SUBJECT: PLANS AND PROPOSAL ADDENDUMS

PROJECT: F 2B24(123)

CONTROL: 0814-01-036

**PROPOSAL ADDENDUMS**

HYDRAULIC DATA

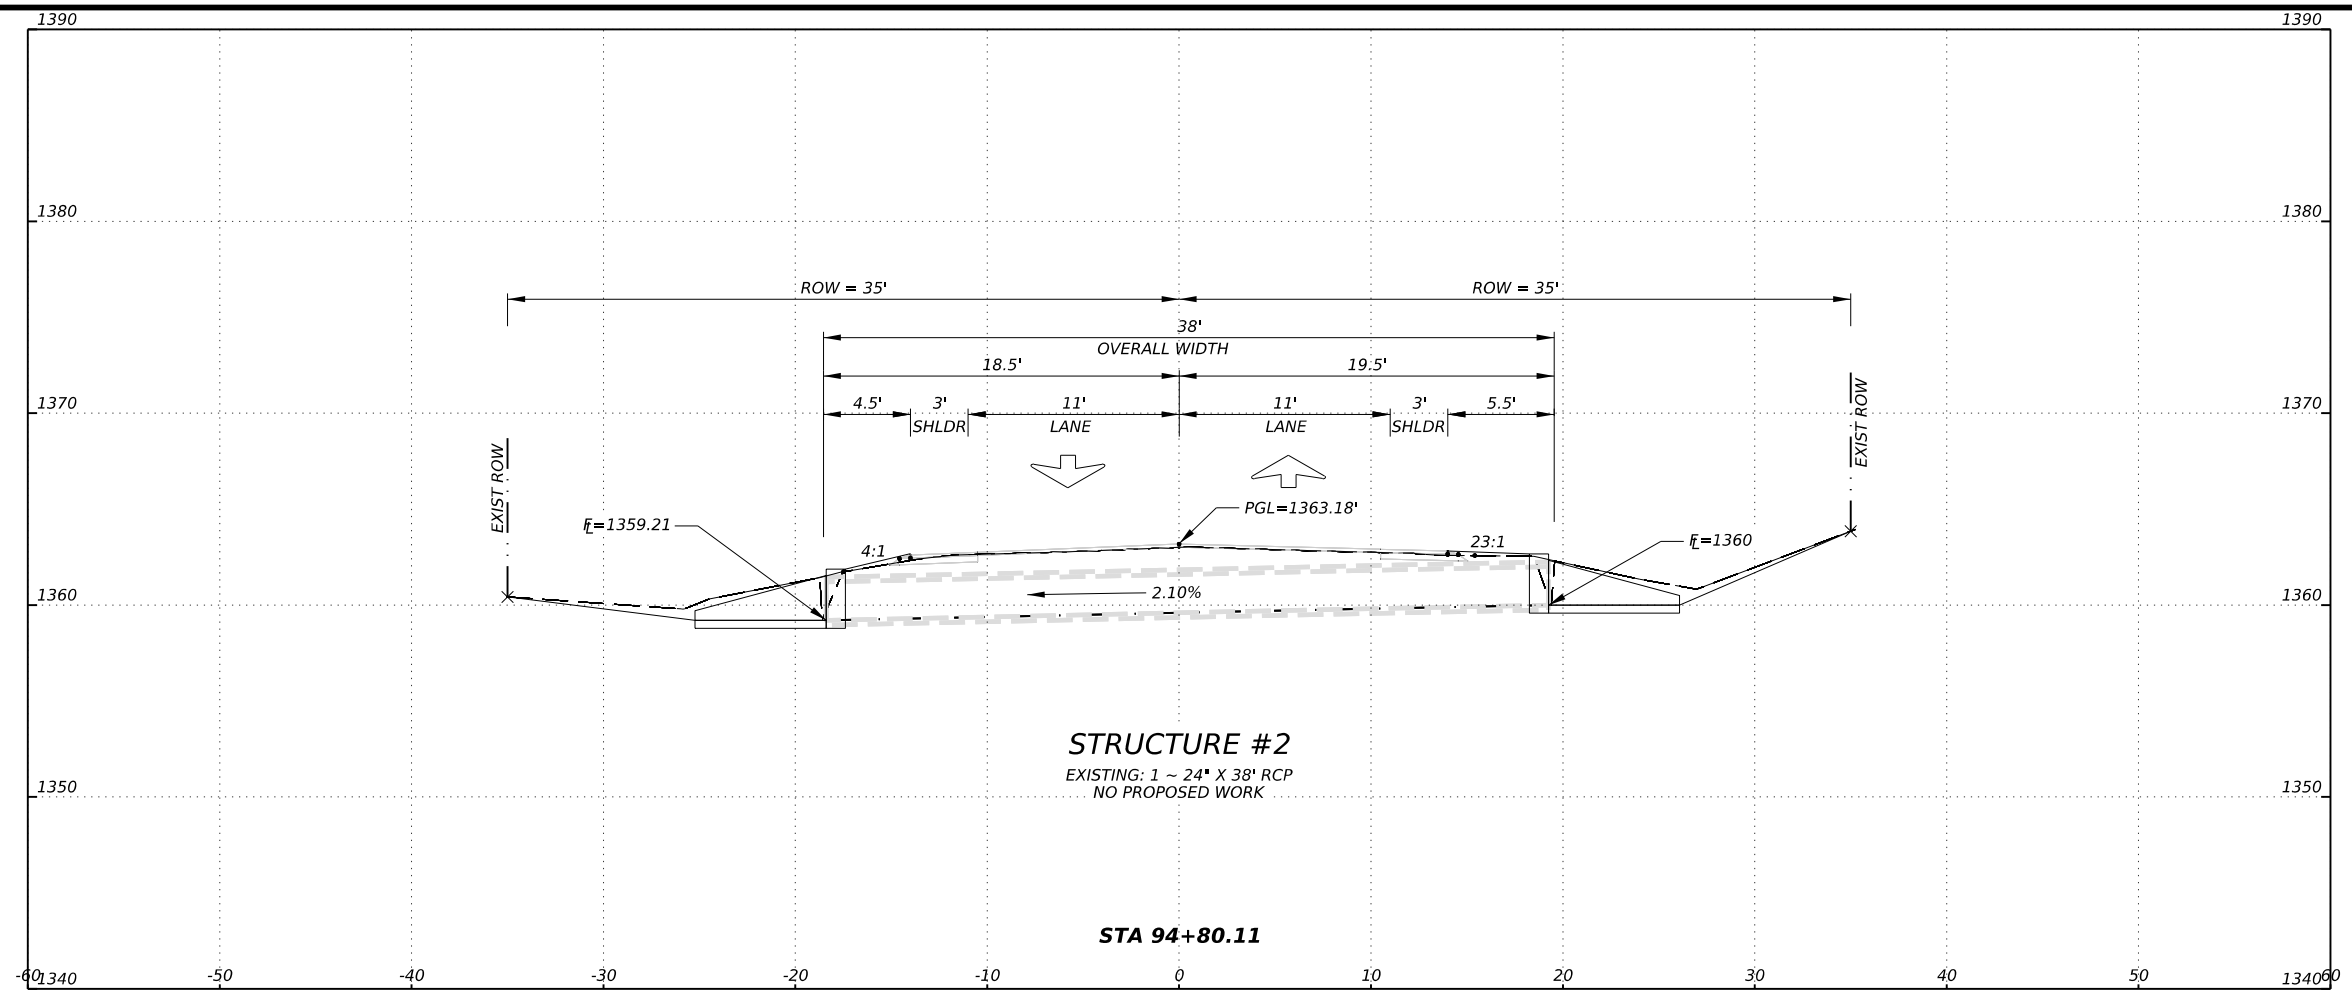
REVISE SHEETS 8, 11-12, 13-15, 74, and 76-82, DUE TO CHANGES ABOVE

Revised 5/23/24

- GENERAL NOTES:
- PRECIPITATION DEPTHS USED WERE OBTAINED FROM NOAA ATLAS 14, VOLUME 11, VERSION 2, OF DEPTH-DURATION FREQUENCY OF PRECIPITATION ANNUAL MAXIMA (AMS) FOR TEXAS LOCATION: SEYMOUR, TX LAT: 33.6325° LON: -99.2897°
  - LAG TIME = 0.7 X TIME OF CONCENTRATION (T<sub>c</sub>)
  - COMPOSITE CURVE NUMBERS WERE CALCULATED USING NRCS CN LOSS MODEL AND ACCOUNTED FOR DIFFERING LAND USE AND HYDROLOGICAL SOIL GROUPS FOUND WITHIN THE RESPECTIVE WATERSHED BY USING THE WEB SOIL SURVEY.
- COMPUTATIONAL NOTES:
- THERE HAS BEEN NO HISTORY OF ANY FLOODING OF THE ROADWAY FOR ALL STRUCTURES LISTED AS PER AREA ENGINEER ZACH HUSEN AND MAINTENANCE SUPERVISOR CRAIG HOSTAS.
  - THESE CALCULATIONS WERE PERFORMED TO VERIFY THAT THE MODIFICATIONS DO NOT SIGNIFICANTLY IMPACT HYDRAULIC PERFORMANCE.
  - RESULTS WERE BASED ON UNOBSTRUCTED FLOW.
  - NO WORK IS TO BE PERFORMED ON STRUCTURE 2

**FM 422  
 CULVERT  
 PROFILES**

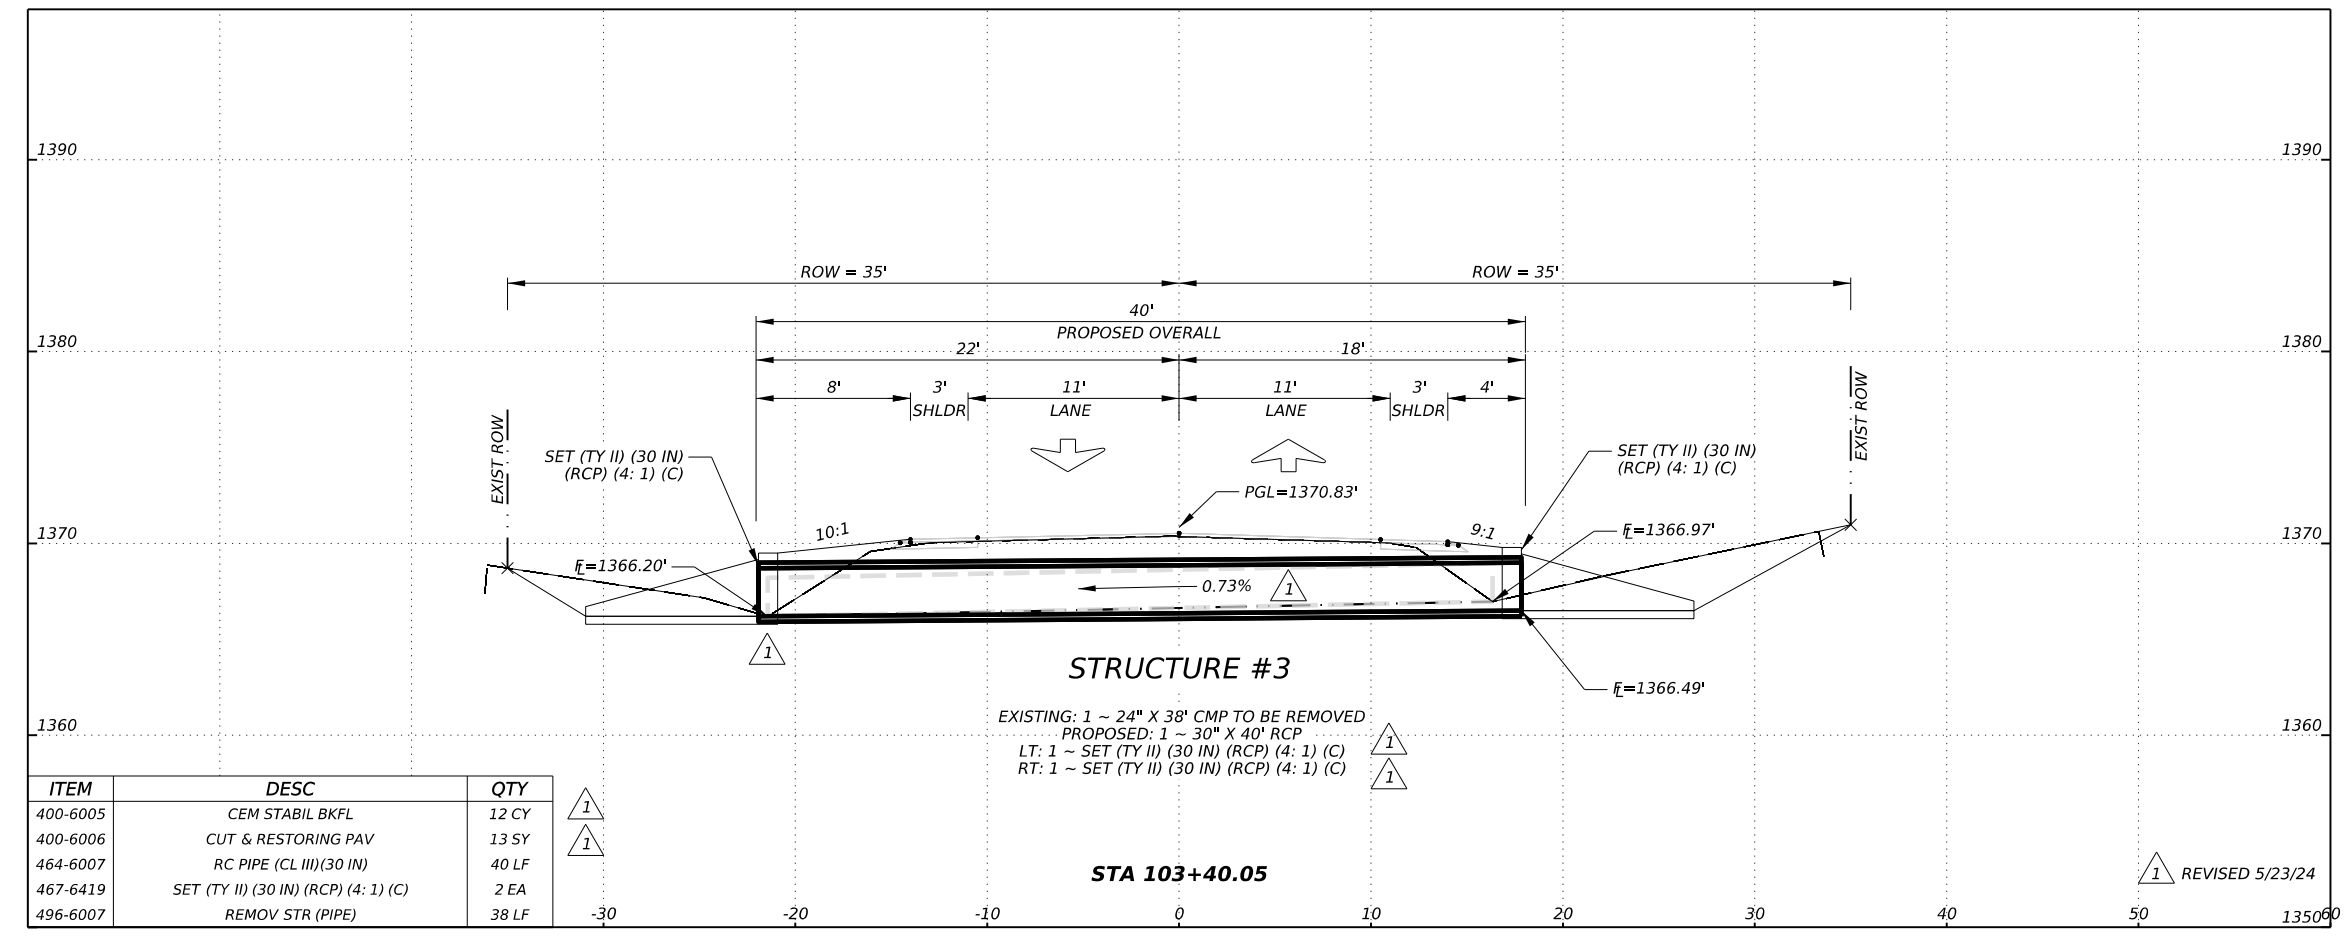
REVISD 5/23/24

**STRUCTURE #2**  
 EXISTING: 1 - 24" X 38" RCP  
 NO PROPOSED WORK

EXISTING: 1 - 24" X 38" CMP TO BE REMOVED  
 PROPOSED: 1 - 30" X 40" RCP  
 LT: 1 - SET (TY II) (30 IN) (RCP) (4: 1) (C)  
 RT: 1 - SET (TY II) (30 IN) (RCP) (4: 1) (C)

ITEM	DESC	QTY
400-6005	CEM STABIL BKFL	12 CY
400-6006	CUT & RESTORING PAV	13 SY
464-6007	RC PIPE (CL III) (30 IN)	40 LF
467-6419	SET (TY II) (30 IN) (RCP) (4: 1) (C)	2 EA
496-6007	REMOV STR (PIPE)	38 LF

LOCATE UTILITIES BEFORE ANY EXCAVATION  
 DEPTHS HAVE NOT BEEN VERIFIED  
 STRUCTURE 2'S SETS ARE IN PLACE AND NO  
 WORK IS PROPOSED  
 FULL DEPTH HOTMIX FOR BOX CULVERTS

**FM 422  
 CULVERT  
 PROFILES**

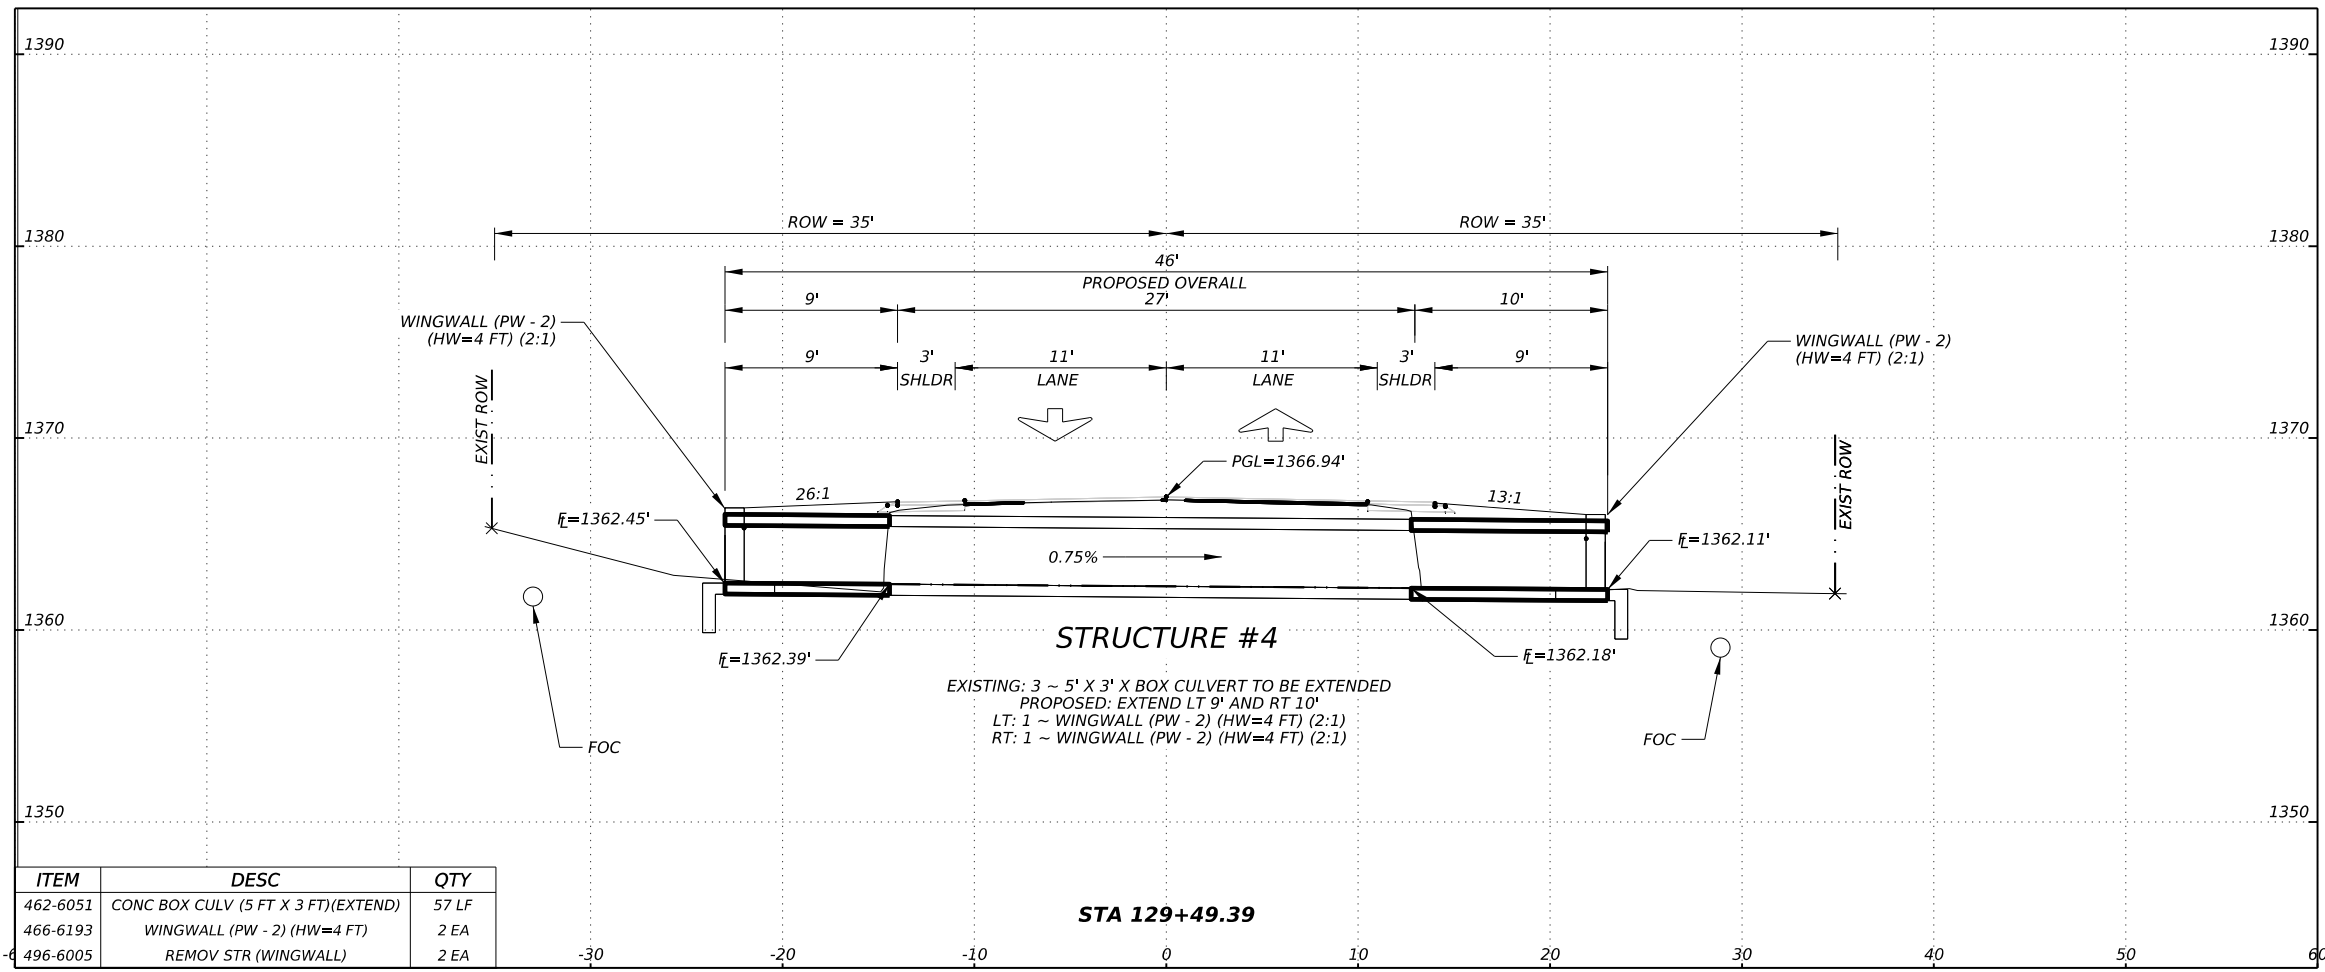
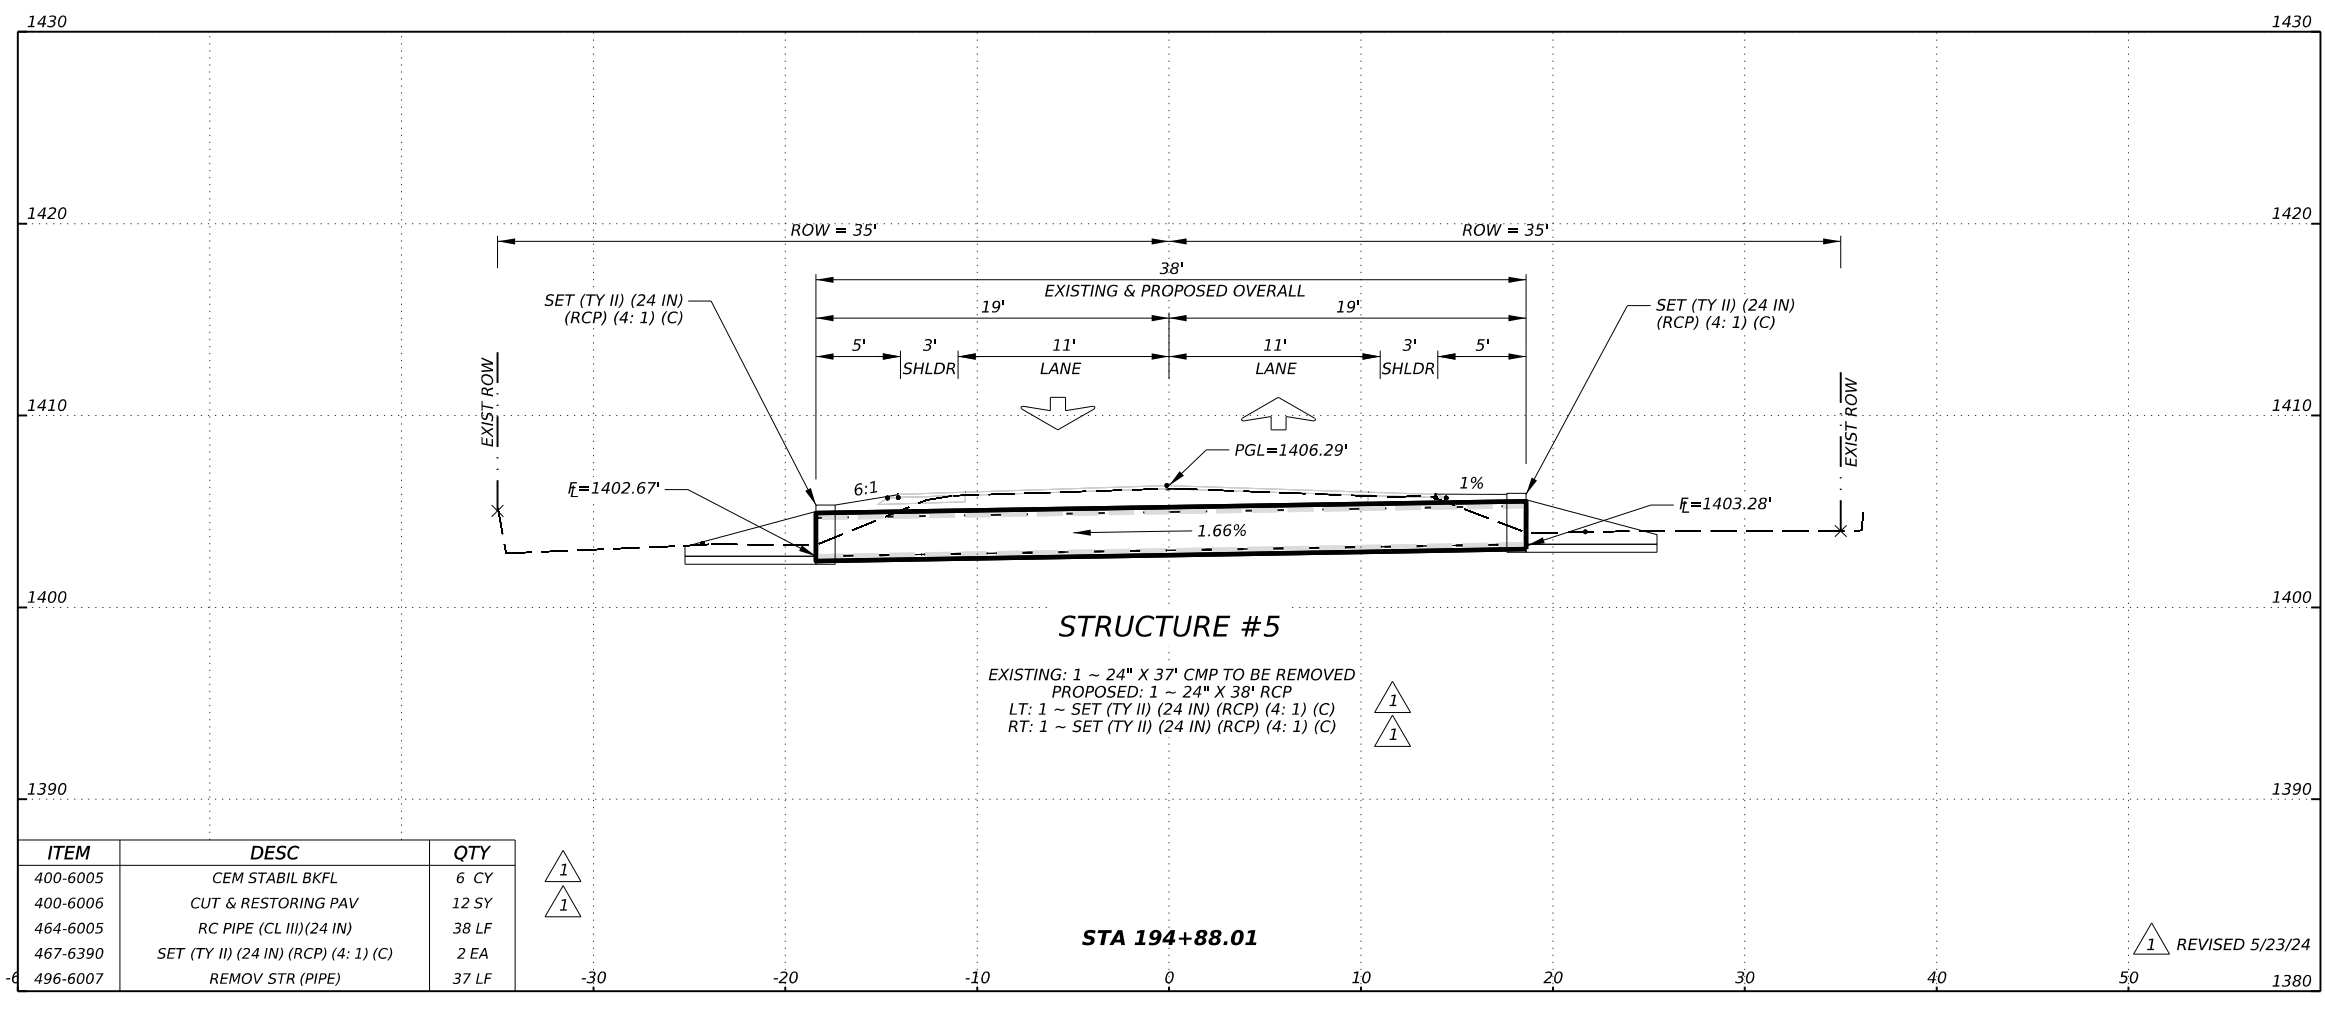
1 REVISED 5/23/24

ITEM	DESC	QTY
462-6051	CONC BOX CULV (5 FT X 3 FT)(EXTEND)	57 LF
466-6193	WINGWALL (PW - 2) (HW=4 FT)	2 EA
496-6005	REMOV STR (WINGWALL)	2 EA

ITEM	DESC	QTY
400-6005	CEM STABIL BKFL	6 CY
400-6006	CUT & RESTORING PAV	12 SY
464-6005	RC PIPE (CL III) (24 IN)	38 LF
467-6390	SET (TY II) (24 IN) (RCP) (4:1) (C)	2 EA
496-6007	REMOV STR (PIPE)	37 LF
